RESPONSE TO REQUEST FOR ADDITIONAL INFORMATION

APR1400 Design Certification

Docket No. 52-046

RAI No.: 155-8167
SRP Section: 06.02.05 – Combustible Gas Control in Containment
Application Section: 6.2.5
Date of RAI Issue: 08/18/2015

Figure 2.11.4-1 Containment Hydrogen Control System Functional Arrangement

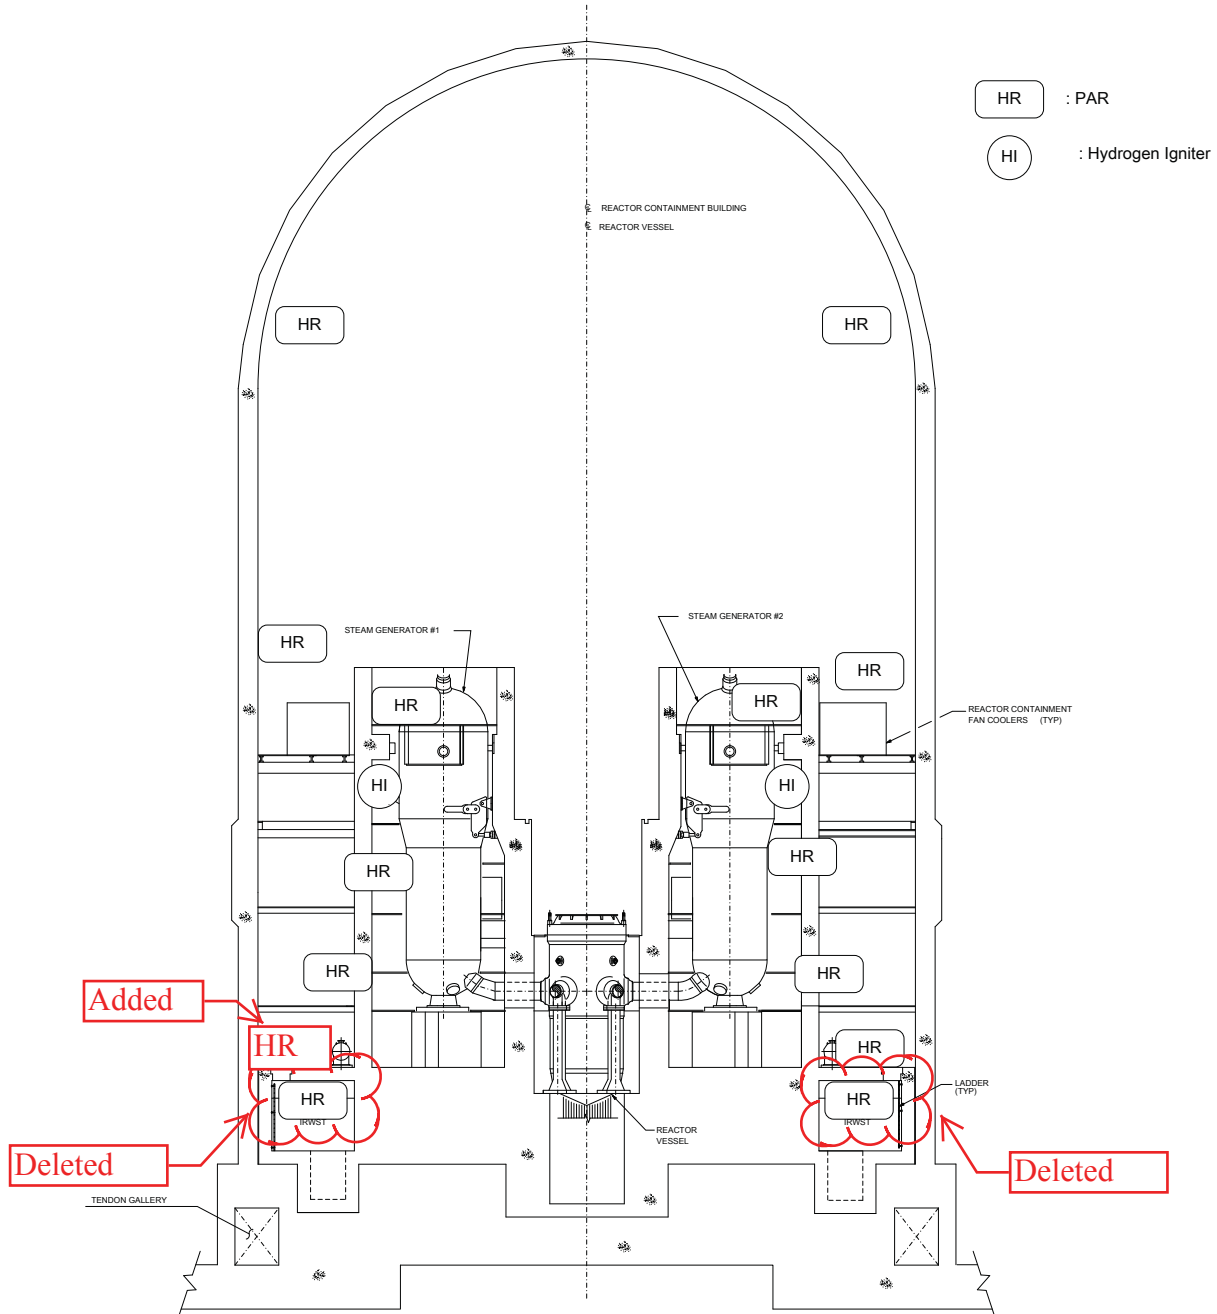
In addition, the following DCD sections and figures contain inconsistencies regarding the location of the PARs with respect to the in-containment refueling water storage tank (IRWST).

- Tier 2, Section 6.8.2.2.5, “IRWST Pressure Devices,” states “The PARs are located at the vent stack area to prevent an accumulation of hydrogen in the IRWST.”
- Tier 1, Figure 2.11.4-1, “Containment Hydrogen Control System Functional Arrangement”, shows some PARs inside the IRWST.

Please clarify the location of the PARs with respect to the IRWST and revise all the affected DCD text, tables, and figures accordingly.

Subsection 6.2.5.2.1, 6.8.2.2.5, Table 6.2.5-1, and Table 19.2.3-1 in DCD Tier 2 will be revised to indicate the PARs are located “inside the IRWST vent stack”, and the PARs location in Figure 2.11.4-1 and Figure 19.2.3-1 will be revised from the IRWST to inside the IRWST vent stack, as indicated in Attachment 2 of this response. In addition, the IRWST vent stack will be added to Figure 6.2.5-1.

In DCD Tier 2, Subsection 6.2.5.2.1 and 6.8.2.2.5, Table 6.2.5-1 and 19.2.3-1, Figure 2.11.4-1, 6.2.5-1 and 19.2.3-1 will be revised as indicated in Attachment 2 of this response.
